CITY OF JOPLIN
Senior Center-Meals On Wheels
Zone Improvement Project
CDBG-DR GRANT
No. B-12-MT-29-0001

Addendum No. 2

The following changes have been made to the plans and specifications:

TITLE SHEET

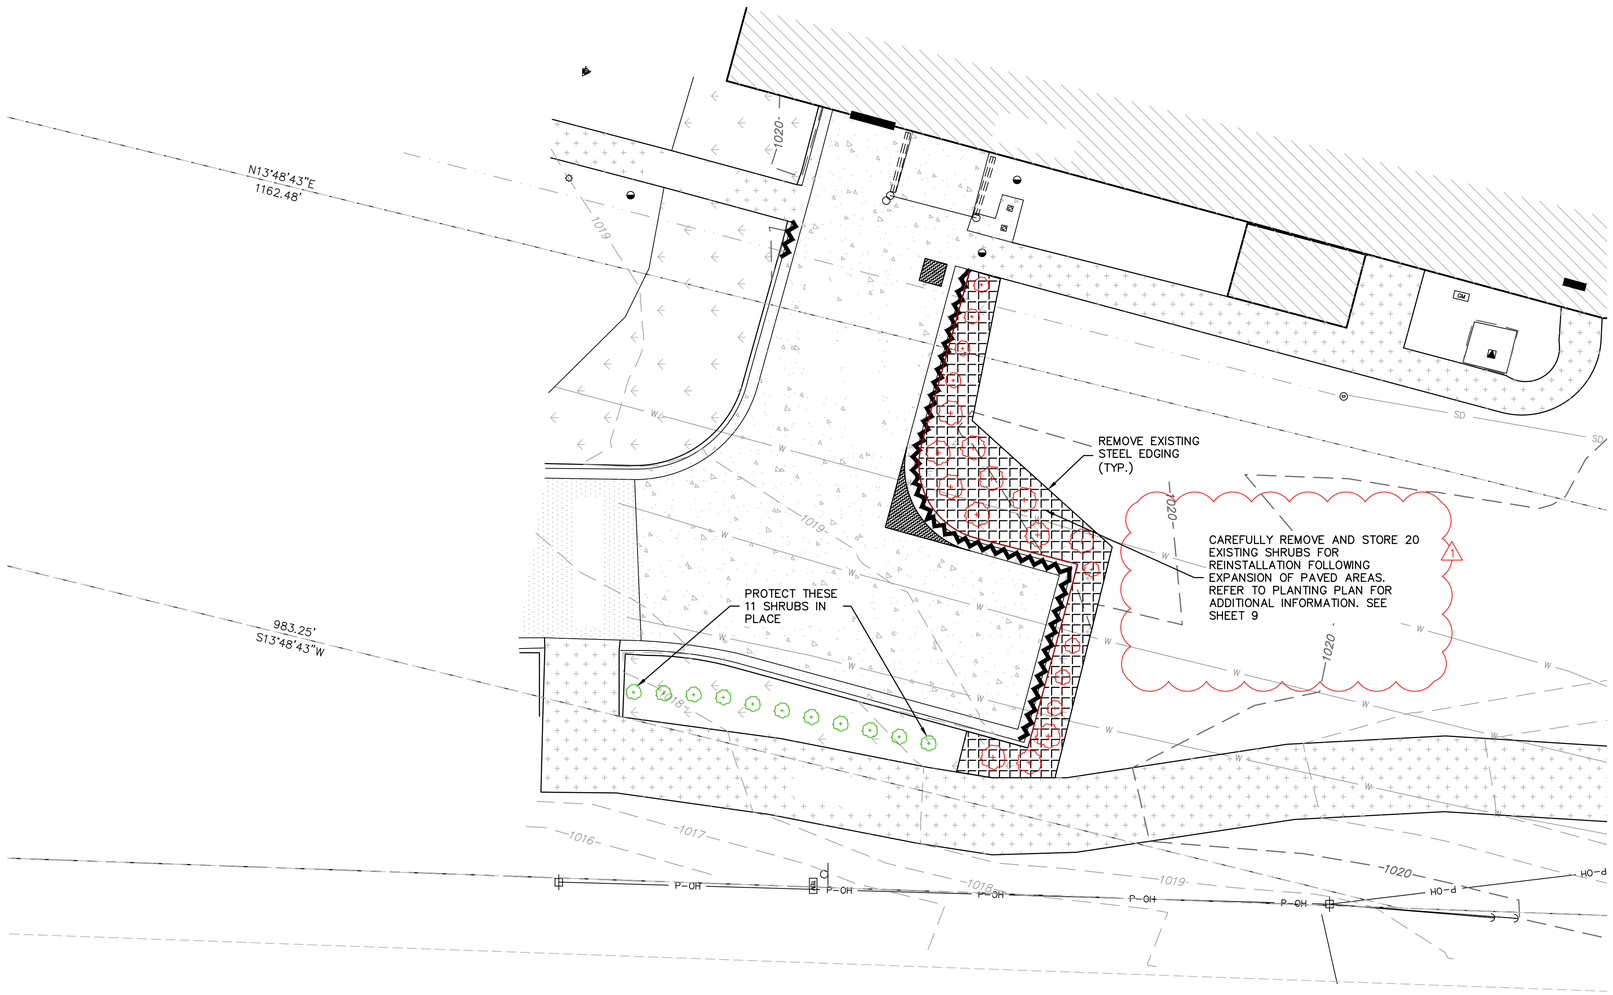
Sheet 1
- Updated the site address.

DEMOLITION PLAN

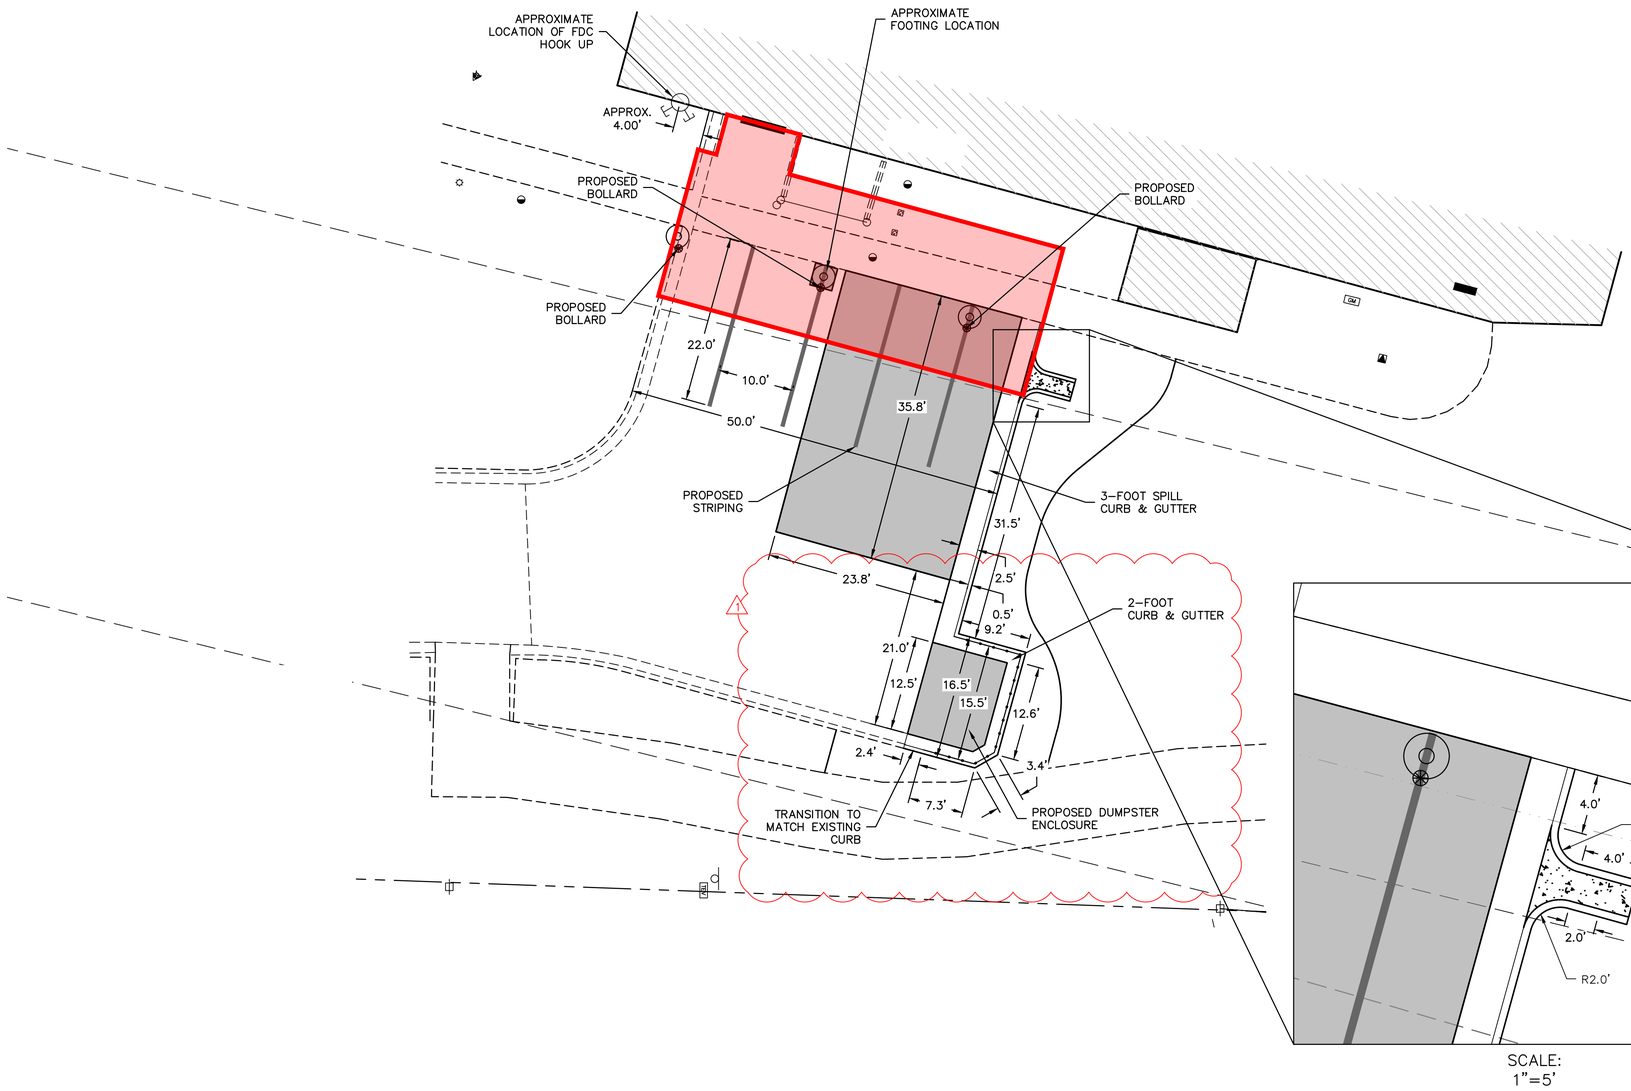
Sheet 3
- Adjusted the sheet number for the callout referencing the planting plan.

SITE PLAN

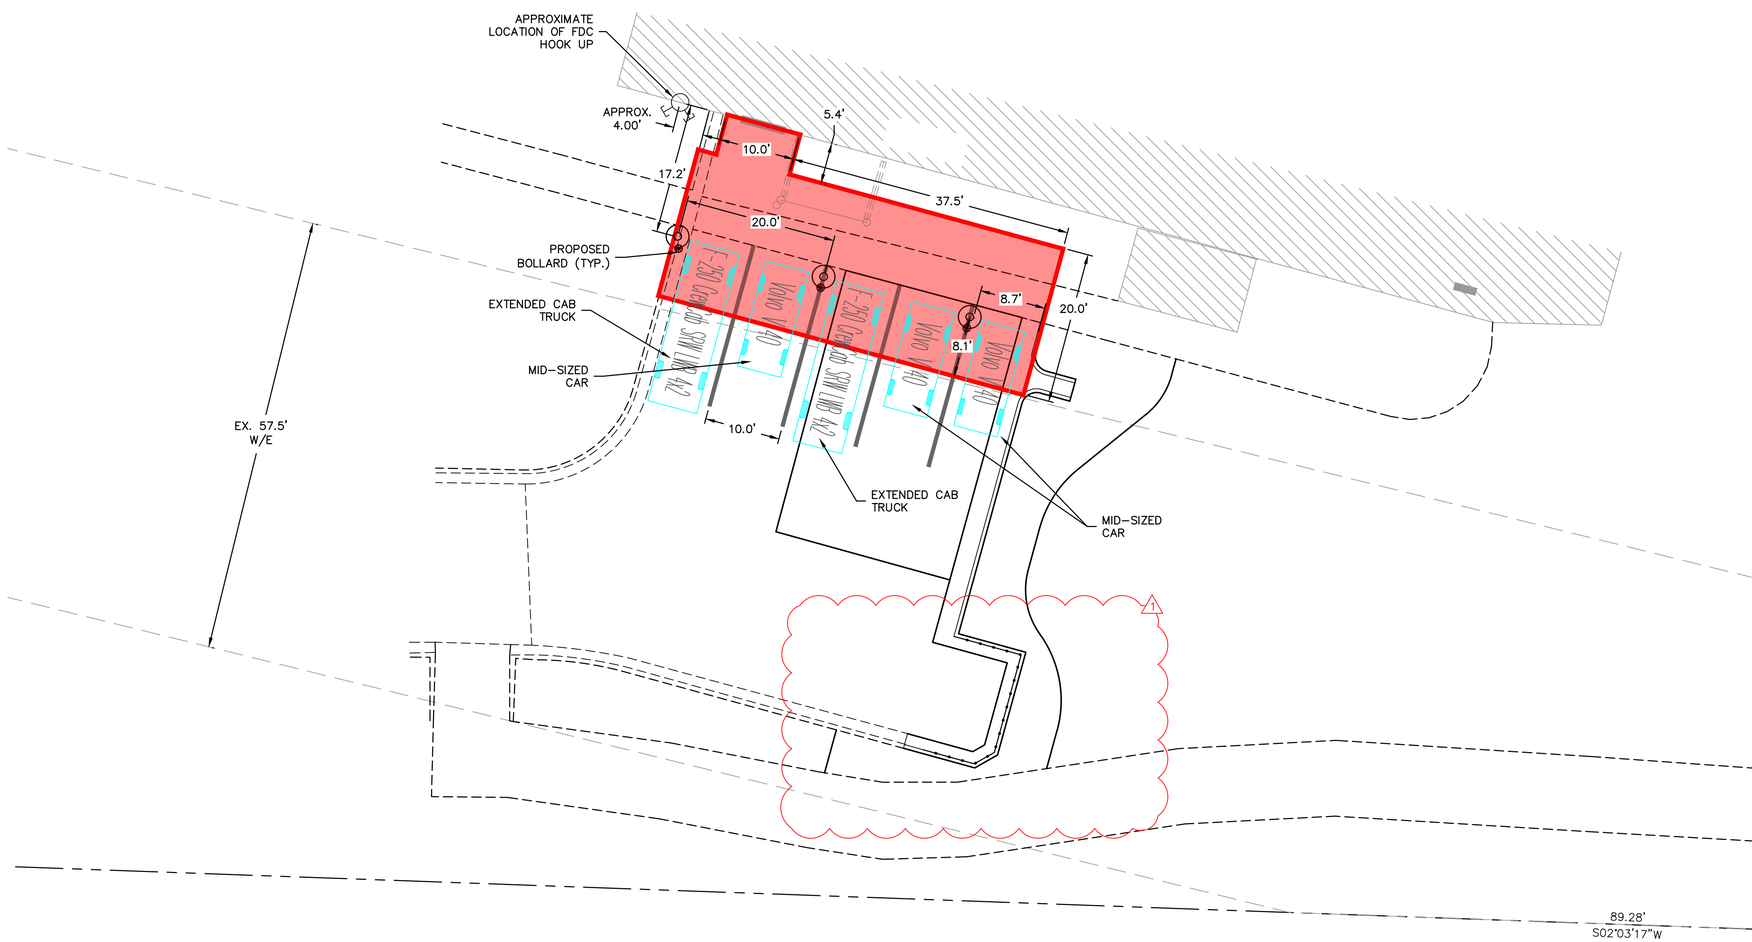
The dumpster enclosure concrete area has been revised see plan sheet revisions.

The dumpster enclosure system has been changed see plan sheet revisions.

Sheet 4
- Increased the dumpster enclosure size an additional 4.5 feet.
- Added requirements for dumpster enclosure materials and hardware to the general site plan notes.
- Added the site address to the sheet.

7. 1-FOOT DUMPSTER BUMPER AROUND ENCLOSURE. VERIFY AND ADJUST HEIGHT OF BOARD BASED ON DUMPSTER LIFT POINTS.
8. ENCLOSURE TO BE CITYSCAPES CORVIT DUMPSTER ENCLOSURE SYSTEM, OR EQUAL

- 8.1 SURFACE MOUNT
   - 8.2 VERTICAL PLANK
   - 8.3 FITTED CAP
   - 8.4 LATCH & HANDLES
   - 8.5 DROP PINS
9. SITE ADDRESS: 2616 PICHER AVENUE JOPLIN, MISSOURI 64804

AWNING PLAN

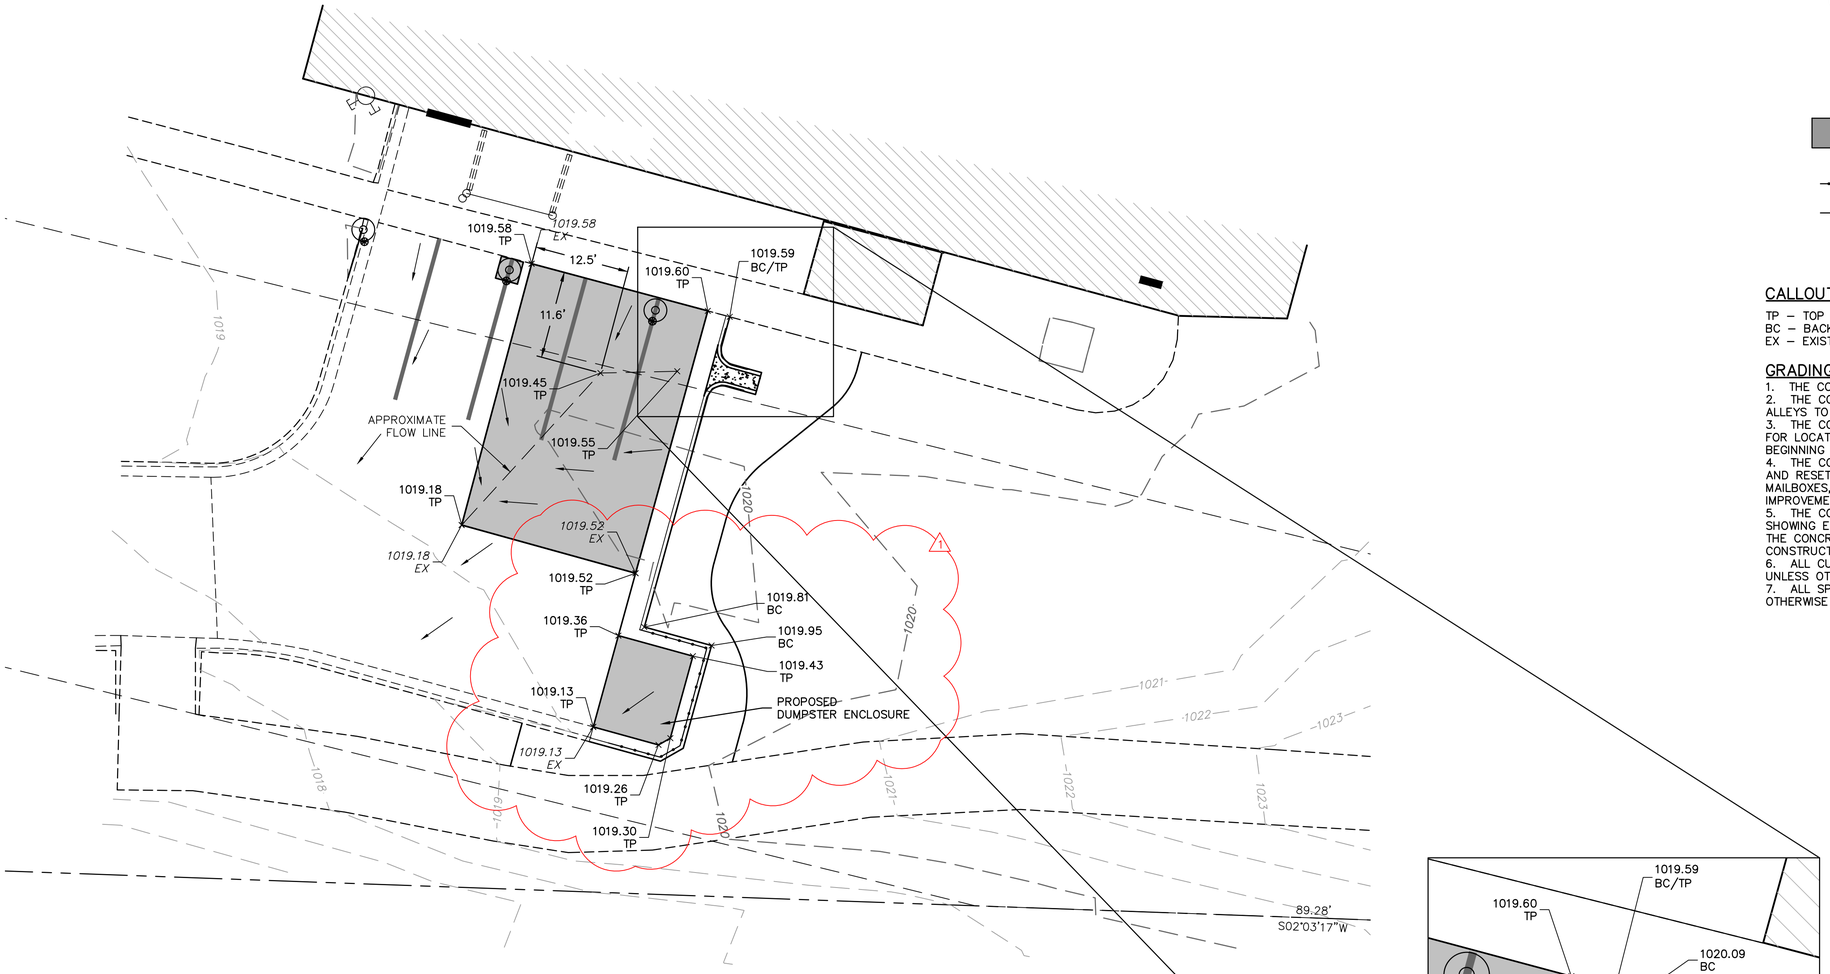
The awning may utilize up to 2 additional columns along the west side. The columns must not interfere with other utilities or the existing dumpster enclosure.

Sheet 5
- Increased the dumpster enclosure size an additional 4.5 feet.

COMPOSITE FENCE DETAIL REMOVED FROM SHEET. SEE SHEET 4 FOR DUMPSTER ENCLOSURE MATERIALS AND REQUIREMENTS

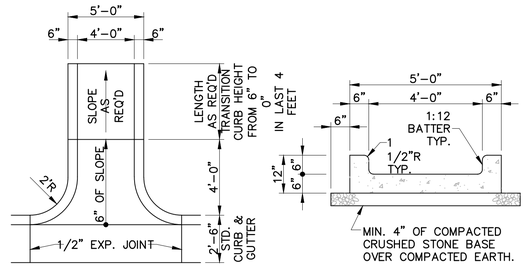
Sheet 10

- Removed previous composite fence detail and relocated the dumpster enclosure requirements to the general notes section on the Site Plan (Sheet 4)
